## Labor Saver™: 2016-2002 GM 1500 Truck & SUV Front Lower Ball Joint (Aluminum Control Arm)

Brand	Supreme	Product	Ball Joint	Date	December 2022
Part Number(s)	MK500007

**Figure 1.** Mevotech Supreme front lower ball joint MK500007 can be secured to the control arm easily via the included circlip (left) vs OEM stake/crimp method (right)

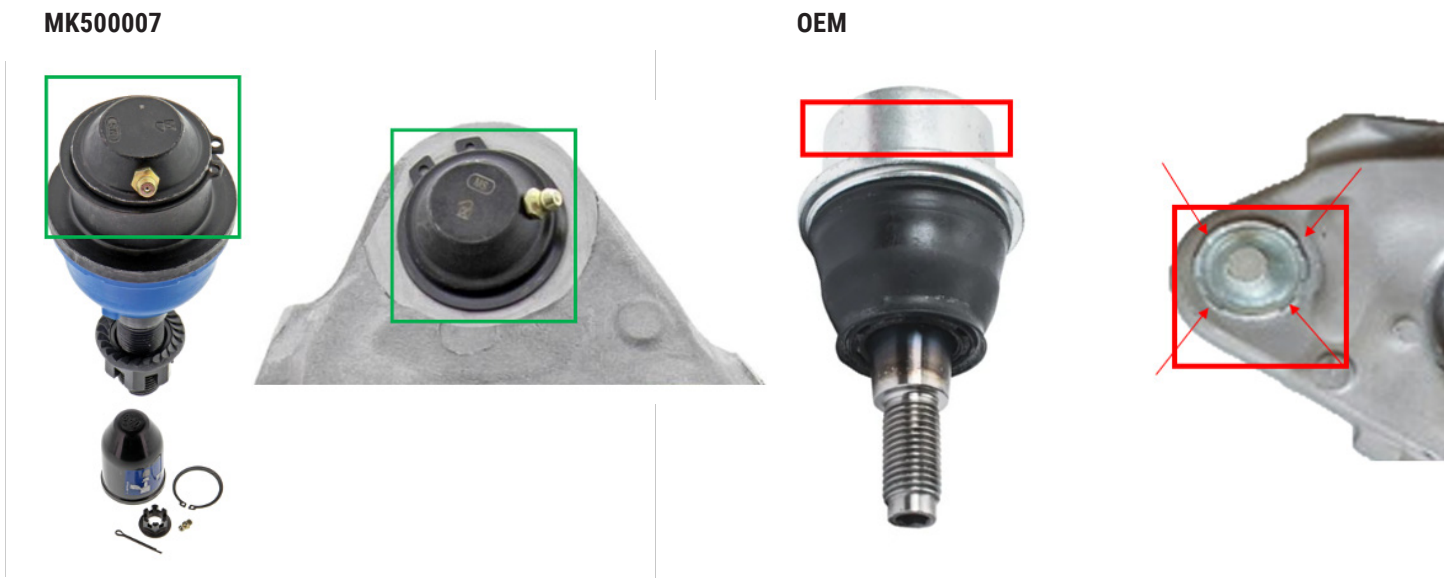
The OEM (PN: 19256481 and various other OE-style) front lower ball joints for the applications associated with the below listed part number require to be staked/crimped after press-in.

Mevotech Supreme front lower ball joint MK500007 is engineered to utilize a circlip as the supplementary retention method. This reduces installation time for the Professional Technician and is a frustration-free alternative to the staking/crimping method. Additionally, the potential of damage to the control arm body is limited when securing the ball joint after press-in. **See Figure 1.**
